Re: 520 Archer Avenue
Travel Time

September 12, 2001

Enclosed are the drawings, recommendations, and preliminary cost estimate for your building at 520 Archer Avenue. The proposed changes include: removal of the wood storefront, paint scheme, new awnings, and new double-hung windows.

TRAVEL TIME

ELEVATION

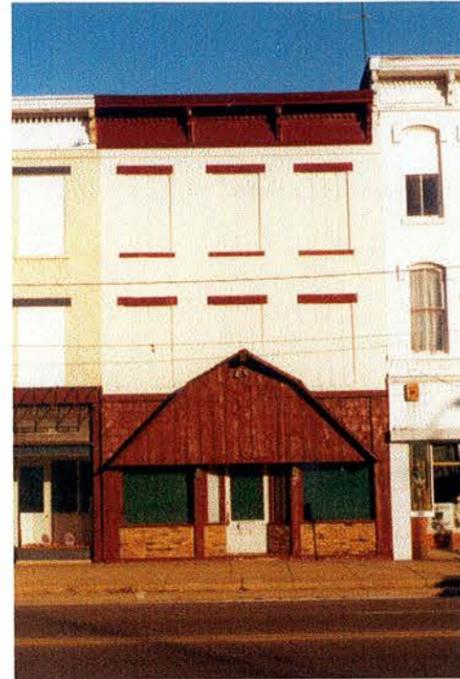
It appears that your upper-façade windows are no long in place. If this is the case, I suggest you install new wood windows that match the size and appearance of the original windows. If the original wood windows still exist, I urge you to retain and repair them as needed. I have enclosed Preservation Brief 9, which deals with the repair of historic wooden windows. I suggest that you prime and paint the upper-façade windows to give your building a more lively appearance, as indicated in the drawing. The enclosed preliminary cost estimate includes the cost of repairing the original windows and not the cost of installing new wood windows. To project the cost of new wood windows, I would plan for \$250 per window.

I have chosen a striped awning, *Blended Green Tailored Bar Strip*, with a solid valance, *Oyster*, from Sunbrella, which coordinates with the new paint scheme. The new fixed-frame fabric awnings should be mounted below the lintel and between each column, as shown. This will give you more clearance while highlighting the columns. The new awnings will help shelter passersby, reduce glare, and conserve energy by limiting the amount of sunlight hitting the store windows.

As for signage, I suggest you apply "TRAVEL TIME" and 520 to the valances of the awnings, as shown. The lettering is to be in dark green in the BauerBodniBT (Normal) or equivalent font style.

Remove existing wood storefront.

Furnish and install new upper-façade double hung windows if original windows are not present.

Furnish and install new display windows.

Furnish and install three awnings with signage.

Paint as shown.

For the building's paint scheme, I chose Sherwin Williams' *Olympic Range* (SW 2385), *Concord Buff* (SW 2339) and *Lanyard* (SW 2190) to highlight the important features of the building and Sherwin Williams' *Farmhouse* (SW 2301) as the over all brick color.

The existing brick is to be painted as indicated in the drawing. Complete removal of all old coatings prior to repainting is not necessary. However, foreign materials such as dirt, loose mortar, peeling or scaling paint should be removed to assure a sound bonding to the tightly adhering old paint. I suggest that you use a garden hose, a medium soft bristle brush, and possibly a household detergent to clean the brick. Keep in mind that no exterior painting should be done immediately after a rain, during foggy weather, when rain is predicted, or when the temperature is below 50°F. I have enclosed Preservation Brief 1, which provides guidance on cleaning techniques and explains the consequences of waterproofing masonry building.

The pressed-metal cornice is to be retained and painted as indicated. Before painting begins, the surfaces should be properly prepared to insure a more lasting finished product. First, the surface must be cleaned of all dirt, loose paint, and rust, which is best done by hand with a wire brush. Paint that remains adhered to the surface may remain. The newly exposed metal surface should then quickly be primed with a rust-inhibitive primer, such as Sherwin Williams DTM Acrylic Primer/Finish, or

Scrape, prime, as needed, and paint upper-façade windows as shown. The window sashes are to be painted with two coats of Sherwin Williams' *Olympic Range* (SW 2385) or equivalent. The windowsills and lintels are to be painted with two coats of Sherwin Williams' *Lanyard* (SW 2190) or equivalent.

The cornice is to be painted with two coats of Sherwin Williams' *Olympic Range* (SW 2385), *Concord Buff* (SW 2339) and *Lanyard* (SW 2190) or equivalent as shown in drawing.

Furnish and install new full-length display windows, as shown in the drawing, if the original windows no longer exist.

Furnish and install a new fabric awning and frame below the lintel and between the columns, as shown. I suggest that you use Sunbrella's *Blended Green Tailored Bar Strip* (#4944). As for the valance, I suggest that you use Sunbrella's *Oyster* (#4642) with Travel Time and 520 applied in hunter green to the valances in the BauerBodniBT (Normal) or equivalent font style.
